AMA Designers Response to Stage 1 Road Safety Audit

Proposed Residential Development – Hart Road, Thundersley

2nd February 2022

Road Safety Audit: Stage 1

Appendix 2 – Problem Location Plan

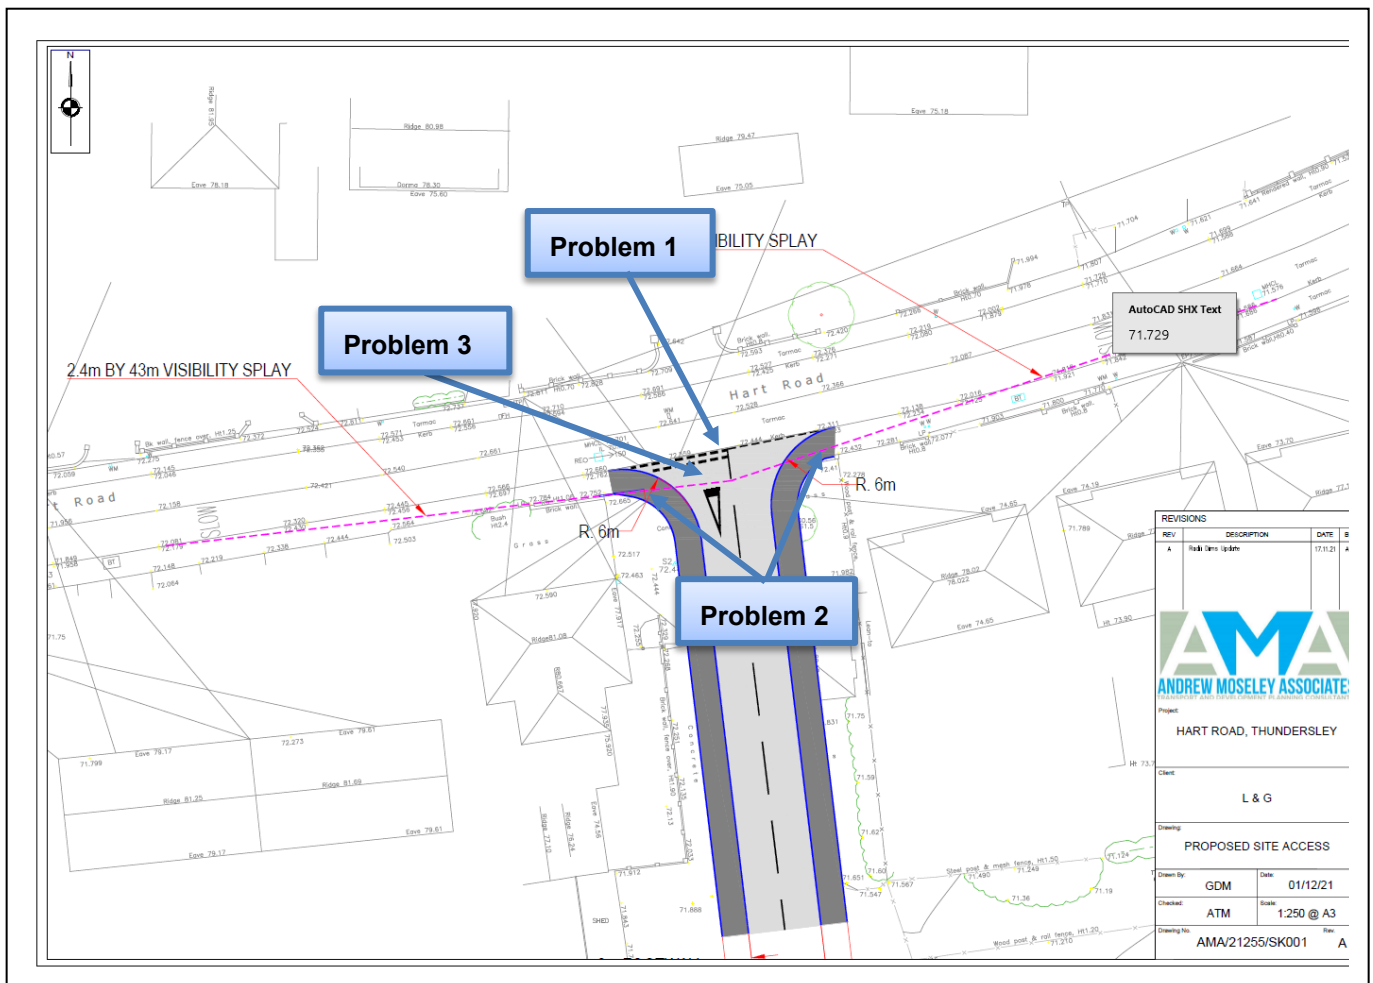
This section details the findings of this Stage 1 Road Safety Audit. All locations of identified problems are illustrated on the plan included at **Appendix 2**.

PROBLEM		1
Location:	Hart Road	
Summary:	Inappropriate drainage will increase the risk of ponding water causing the likelihood of both vehicle loss of control and pedestrian slips/trips/falls.	
<p>As part of the scheme, it is proposed to install a new priority-controlled junction with Hart Road. Running along the existing dropped kerb line is a system of 'ACO' type kerb drain. Details have not been provided of how this will either be maintained or replaced once the new junction is installed.</p> <p>The Audit Team were concerned that this could affect the drainage resulting in standing water at the new junction which will increase the risk of loss of control type collisions and during cold weather could freeze increasing the risk of pedestrian slips and falls.</p>		
RECOMMENDATION		
At detailed design carefully consider how the drainage at this location will be maintained once the junction is constructed.

PROBLEM		2
Location:	Hart Road.	
Summary:	A lack of suitable uncontrolled crossings will increase both the risk of pedestrian trips and falls as well as pedestrian-vehicle collisions.	
<p>The drawings provided do not show any crossing facilities of the new site access. There is an existing footway along Hart Road that the new access will bisect.</p> <p>A lack of suitable uncontrolled crossings will increase both the risk of pedestrian trips and falls as well as pedestrian-vehicle collisions.</p>		
RECOMMENDATION		
Ensure that appropriate tactile paving layouts and dropped crossing points are provide.

PROBLEM		3
Location:	Site access	
Summary:	Inappropriately located telegraph pole and chamber covers can increase the risk of collisions as well as cycle/powered two-wheeler loss of control.	
<p>The drawings provided do not indicate what will happen to the existing telegraph pole and service chambers within the proposed site access. The pole appears to be within the new access junction and therefore represents a hazard to road users.</p> <p>The service covers will be within the new site access and as such the cover may not provide suitable skidding resistance and in wet conditions may lead to a vehicle, cycle or powered two wheelers losing control.</p>		
RECOMMENDATION		
Move the service chambers and telegraph pole away from the new site access.

PROBLEM		4
Location:	Internal junctions.	
Summary:	A lack of suitable uncontrolled crossings will increase both the risk of pedestrian trips and falls as well as pedestrian-vehicle collisions.	
The drawings provided do not show any crossing facilities of the new internal junctions. A lack of suitable uncontrolled crossings will increase both the risk of pedestrian trips and falls as well as pedestrian-vehicle collisions.		
RECOMMENDATION		
Ensure that appropriate tactile paving layouts and dropped crossing points are provided within the internal road layout.

PROBLEM		5
Location:	Internal roads.	
Summary:	Inappropriate drainage will increase the risk of ponding water causing the likelihood of both vehicle loss of control and pedestrian slips/trips/falls.	
As part of the scheme, it is proposed to install a new road network with junctions, access roads and raised ramp features. A lack of drainage will increase the risk of ponding water causing the likelihood of both vehicle loss of control and pedestrian slips/trips/falls.

PROBLEM		6
Location:	Internal roads.	
Summary:	Inappropriate levels of lighting can lead to an increased collision risk.	
<p>The drawing provided does not clearly show if street lighting is proposed. The scheme will include a new junctions and internal roads and increase both the night time usage and the number of vehicles/NMUs using the proposed road network once constructed.</p> <p>This may result in the new road layout being in shadow leading to possible conflicts during the hours of darkness.</p>		
RECOMMENDATION		
Ensure that suitable lighting provision is provided.

PROBLEM		7
Location:	Attenuation pond.	
Summary:	A lack of protection will increase the risk of NMU injury.	
<p>As part of the scheme a new attenuation pond will be provided. The Audit Team were concerned that there is no fencing surrounding the pond. Without fencing there is no way to stop a person from falling down the embankment into the pond.</p> <p>A lack of protection will increase the risk of NMU injury.</p>		
RECOMMENDATION		
<p>Consider at detailed design the need for protection in the form of fencing around the attenuation pond.</p>

As part of the Section 278 design, a detailed drainage design will be included and will address any concerns raised.

An uncontrolled pedestrian crossing at the mouth of the access junction is proposed in the form of dropped kerbs with tactile paving.

Both the inspection chamber and telegraph pole will be relocated to an appropriate location within the footway behind the access kerb radii. Full details of the proposed relocation will be provided and agreed as part of the Section 278 design package.

The specific details regarding the appropriate location and make-up of the dropped kerb pedestrian crossings will be included within the Section 38 design package.

As part of the Section 38 design, a detailed drainage design will be included and will address any concerns raised with the internal layout. Detail regarding the location and make-up of drainage features will be provided within the S38 design package.

The specific details regarding the appropriate location and form of lighting will be included within the Section 38 design package.

A Road Restraint Risk Assessment (RRRA) will be undertaken to ensure the safety of motorised users within the vicinity of the attenuation pond.
